Service Bulletin

Date JANUARY 1984
Sheet 1 of 9
Bulletin JD.01/84

60. LOWER BALL JOINT SECURING BOLTS

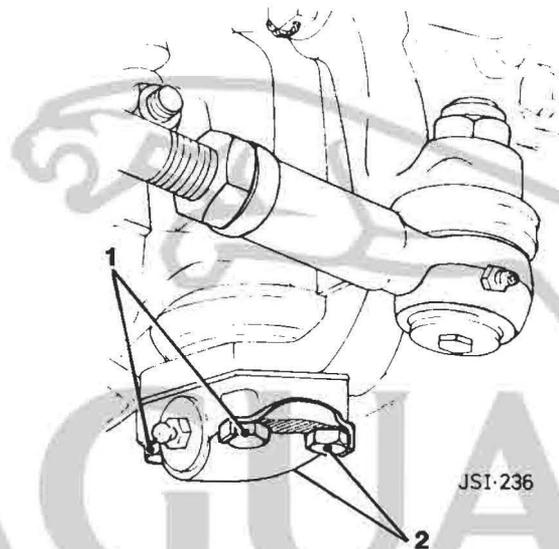
It is important that if any of these bolts are removed during service, they should be replaced in the correct position – see diagram.

LIMOUSINE

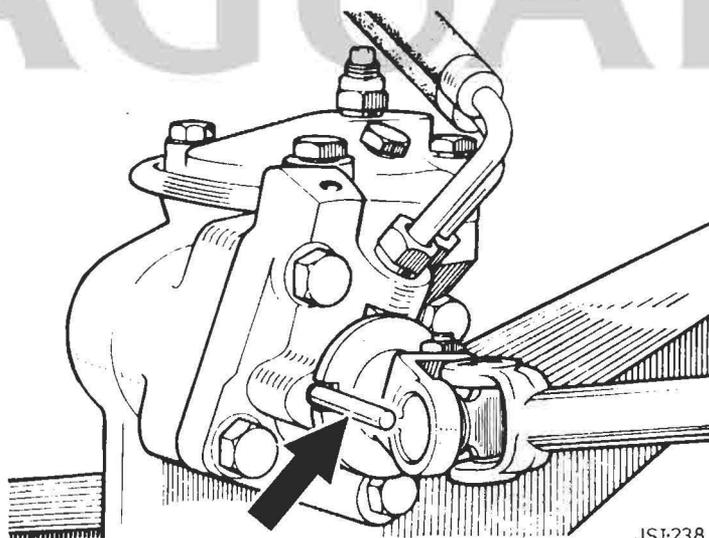
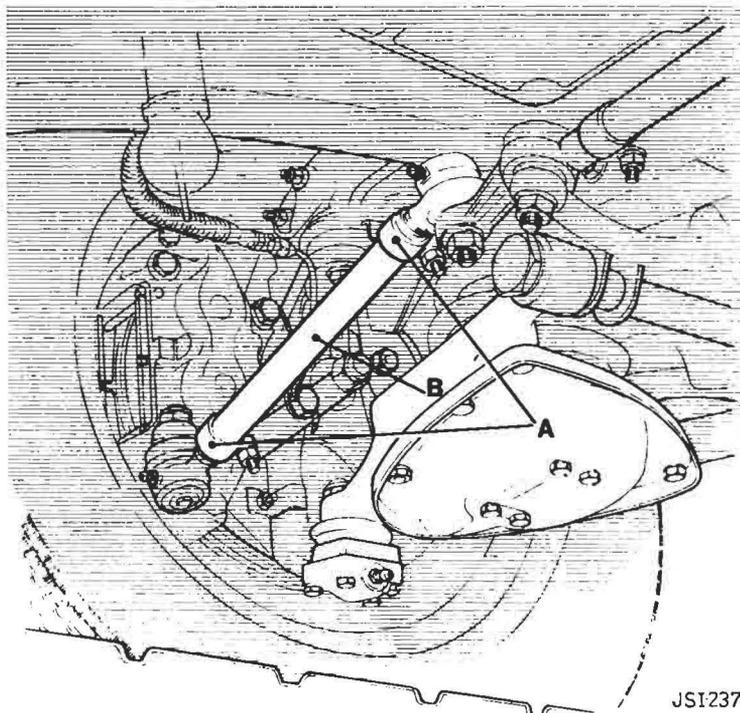
It is essential that the following instructions are observed when checking the front wheel alignment, otherwise steering irregularities may result.

IMPORTANT: The centre tie rod is set to a fixed length of 0.417m (16.4325in) and must not be used for setting the wheel alignment.

4. Use light beam equipment to check wheel alignment.
5. Adjust the outer tie rod by loosening the clamps (A Fig. 2) at each end of the centre tube (B Fig. 2). The rod length is adjusted by rotating the centre tube (B Fig. 2).
6. When the correct wheel alignment figure is achieved, i.e. half the total toe-in of 0–3.2mm (0–1/8in), secure the clamps.

FIG 1

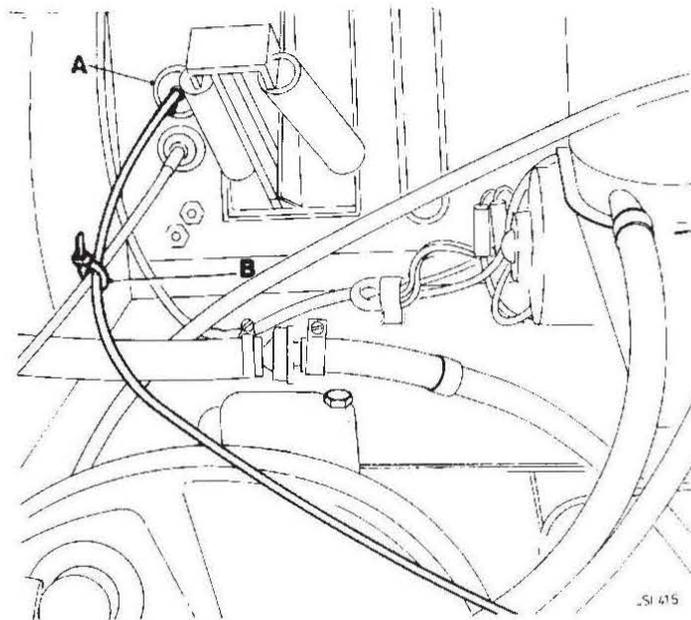
1. Lever the stop plate from the throttle linkage and remove the hot air pick up pipe from the pick up plate on the rear exhaust manifold and the throttle bracket on the inlet manifold. Refit the two nuts to secure the throttle bracket.
2. Remove the blanking plug from the bulkhead, fitted between the offside bonnet hinge and the inner wing valance (A Fig 1).

FIG 2

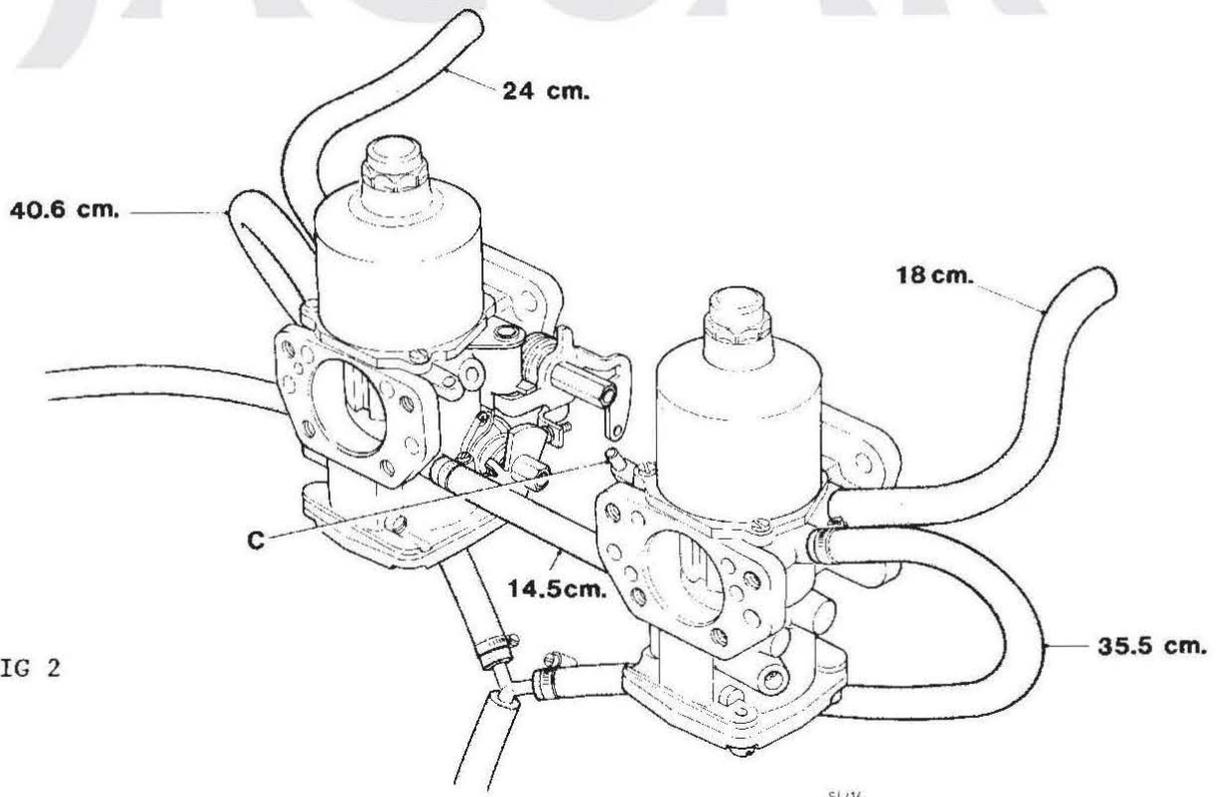
1. Position the throttle, choke connecting rods and levers to the carburettors. Fit the carburettors using gaskets and spacers supplied, ensuring that the smaller diameter of tapered hole in the spacer faces towards the carburettor, and the distributor vacuum hose clip is fitted to the front right hand stud. Secure with nuts and spring washers.
2. Cut the hoses to length, fit and secure to the carburettor using the 'Y' piece from the displaced assembly (Fig. 2), ensuring that they do not and can not foul the operating cams.

3. Fit and secure the lever stop plate ensuring that the two plain washers are located between the lever stop and support bracket to allow adequate clearance for throttle spring. Fit bolt and nut to lever stop plate and adjust for full throttle.
4. Remove the vacuum hose from the distributor, shorten to 35.5 cm (14 ins) long and refit, route through the securing clip located on the front carburettor and attach to the vacuum take off point using the rubber elbow and adaptor from the displaced assembly.
5. Position and tighten the throttle, choke operating levers and link rods to the carburettors.
6. Remove the 'P' clip securing the transmission dip stick tube and relocate the tube away from the throttle linkage to the rear of the bracket. Refit and secure the 'P' clip.

FIG.10

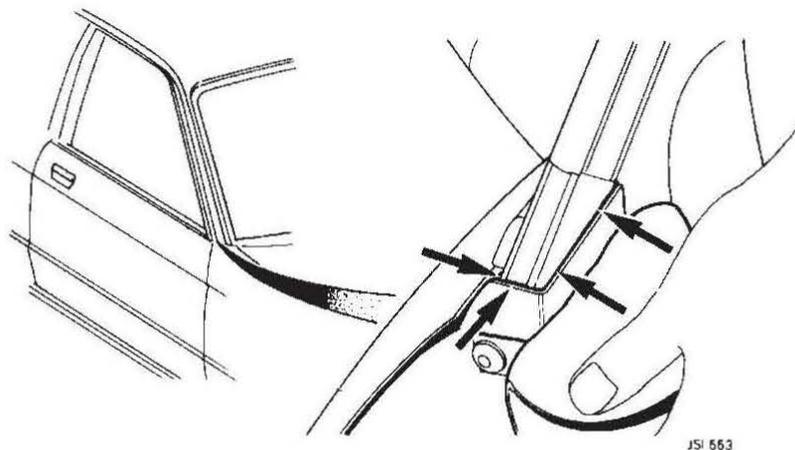
Early cars may be subject to air leakage at this point. This is due to poor/inconsistent fit of the rubber moulded finisher to the body. A modification was introduced on later cars whereby a mechanical fixing operation (plastic rivetting) improved the seal/fit of the rubber moulding.

To correct any leakage at these finishers the following fix should be carried out.

- 1 Remove the rubber finisher (Fig 10) to expose the door to window frame junction.
- 2 Apply sealant 'A' as indicated in Fig 10. Remove any surplus sealant.
- 3 Apply adhesive 'D' to inner surface of the rubber finisher as per adhesive application instructions.
- 4 Refit the rubber moulded finisher pressing firmly to achieve a good bonded seal. Remove any surplus adhesive.
- 5 Road test for wind noise.

FIG 1

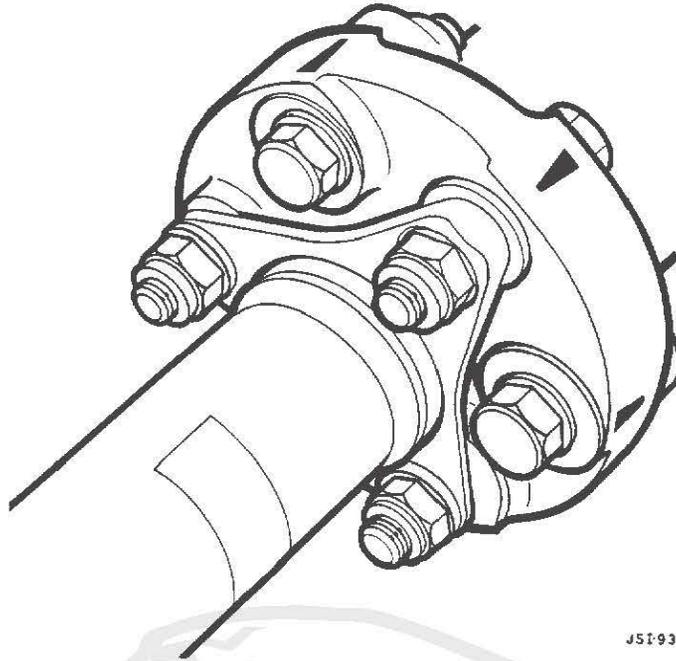
Further to Service Bulletin JD 03/88 Item 22, revised propshaft and final drive units are now fitted to all XJ6 models from the following VINs:-

- Thoroughly clean and regrease the propshaft centring bush prior to reassembly.
- Always renew the coupling fixing bolts, nuts and washers whenever these are disturbed.
- Align the moulded arrows on the circumference of the coupling with the propshaft and pinion flange arms as shown in Fig 1.

JSI 973

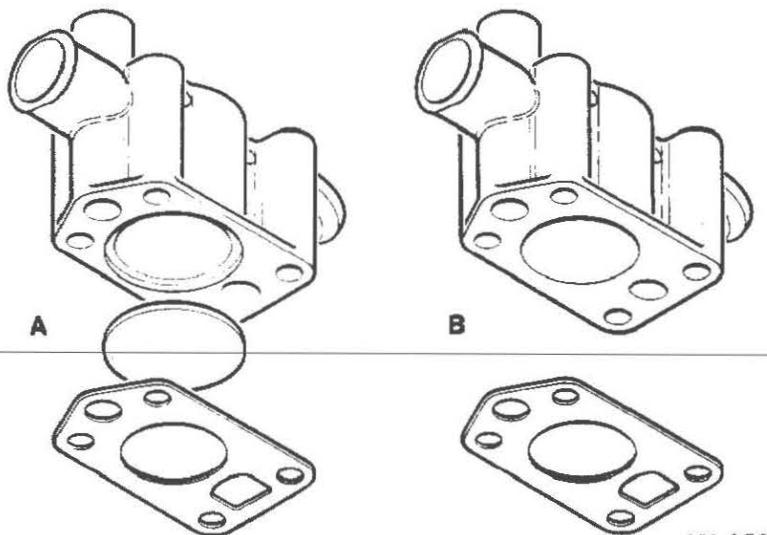
From engine number 9D 143566 a modified idle speed control valve housing, Part No. EBC 2675, with no deceleration valve recess has been fitted (Fig 1 B).

Up to 9D139921	After 9D 139921
Idle Speed Control Valve Housing	EBC 1789	EBC 2675
Induction Manifold XJ6 3.6	EAC 7748	EBC 2054
Induction Manifold XJS 3.6	EAC 8989	EBC 2057
